Subject: 10CFR21 Reporting of Defects and Non-Compliance -
Engine Systems, Inc. Report No. 10CFR21-0110, Rev. 0

CR7 Diode Wiring Reversed: AVR Panel P/N D72-12200-100-PVNGS

Report No. 10CFR21-0110

**10CFR21 REPORTING OF DEFECTS
AND NON-COMPLIANCE**

Figure 1 – Generator Field Flash Schematic

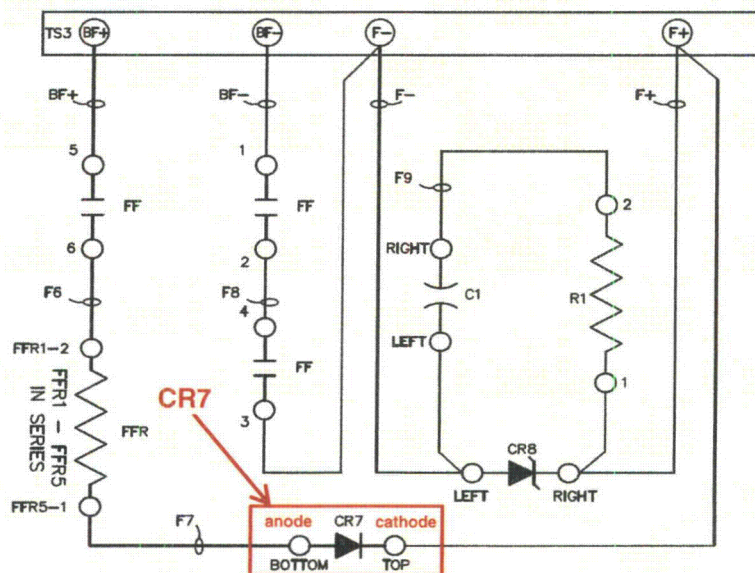
The AVR panel, part number D72-12200-100-PVNGS, is part of the overall static excitation system for the Palo Verde EDGs. Diode CR7 is wired in series with the field flash resistor and a normally open contact from the field flash contactor (FFC) to the generator field (F+) connection. This circuit is only active during startup of the EDG as the generator field is flashed (via an external 125 VDC supply) to initiate generator voltage buildup. CR7 conducts in the forward direction during field flashing to excite the generator field and it prevents reverse current flow when the exciter output begins to increase as the generator comes up to nominal voltage. An electrical schematic of the field flash circuitry is shown below in Figure 1.

Figure 2 – AVR Panel Component Layout

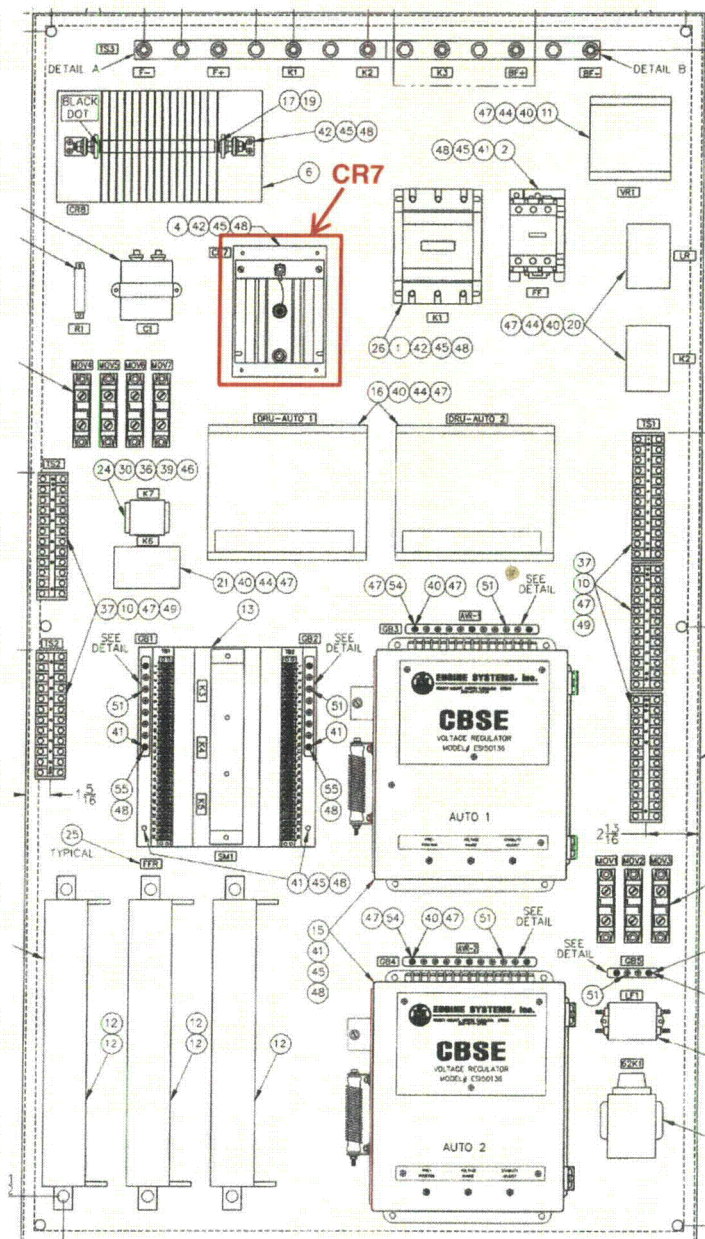
APS-Palo Verde determined during installation testing of the AVR panel that the CR7 diode was installed incorrectly; specifically, the wiring to the anode and cathode was reversed. The CR7 diode assembly consists of a standard power diode (where the mounting stud is the cathode and the terminal end is the anode) mounted on a heat sink. With the diode mounted to the heat sink via the diode stud, the heat sink becomes the diode cathode. A screw installed in the heat sink provides a mounting stud for the CR7 cathode wiring connection(s). The diode anode is wired to another stud at the other end of the heat sink; this stud is electrically isolated from the heat sink and is utilized for the CR7 anode wiring connection(s). Location of CR7 on the AVR panel is shown below in Figure 2.

**CR7 Diode Assembly - Not Correct
(as-shipped)**

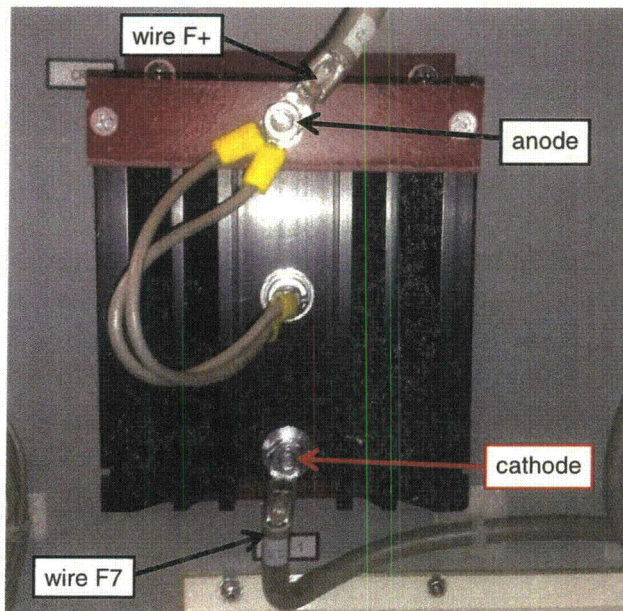
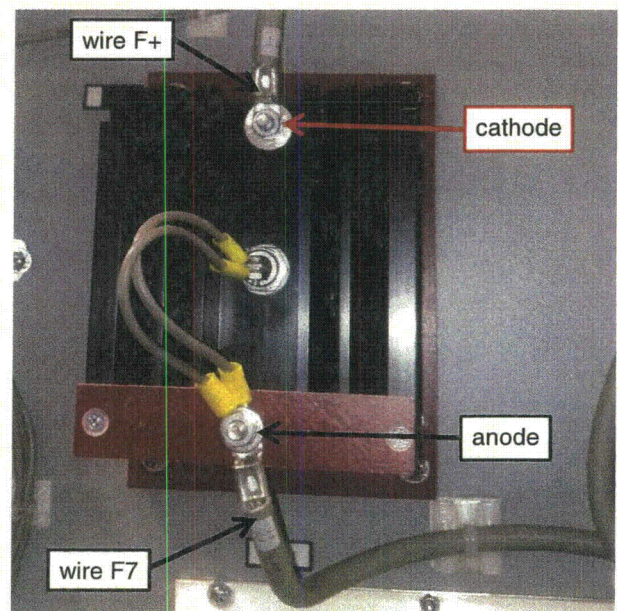
The AVR panel layout drawing (8000654-01) conflicts with the AVR panel electrical schematic and wiring diagram. The layout drawing has CR7 oriented such that the anode connection is on the top and the cathode connection is on the bottom; both the electrical schematic (8000654-02) and the wiring diagram (8000654-11) show the CR7 anode wiring as the “bottom” and the cathode wiring as the “top”. With the layout showing the anode at the top, the CR7 wiring was installed reversed.

- Diode assembly CR7 shall be removed from the AVR subpanel, rotated 180 degrees and re-installed using the same mounting holes and mounting hardware. The existing panel wiring to CR7 shall then be connected in the same physical location, thereby connecting wire F+ to the cathode and wire F7 to the anode as shown in the photographs below. This shall be performed on all five (5) AVR panels shipped to APS-Palo Verde (reference ESI sales order 8001720).

**CR7 Diode Assembly - Correct
(rotated 180°)**

- To prevent recurrence of this issue, the following is being implemented:
 - AVR panel layout drawing 8000654-01 has been revised to rotate diode CR7 180 degrees. This will change the anode connection from the top to the bottom orientation.
 - The AVR panel factory test procedure 8000654-FTP-1 has been revised to include steps to verify proper connection of diode CR7 within the field flash circuitry.
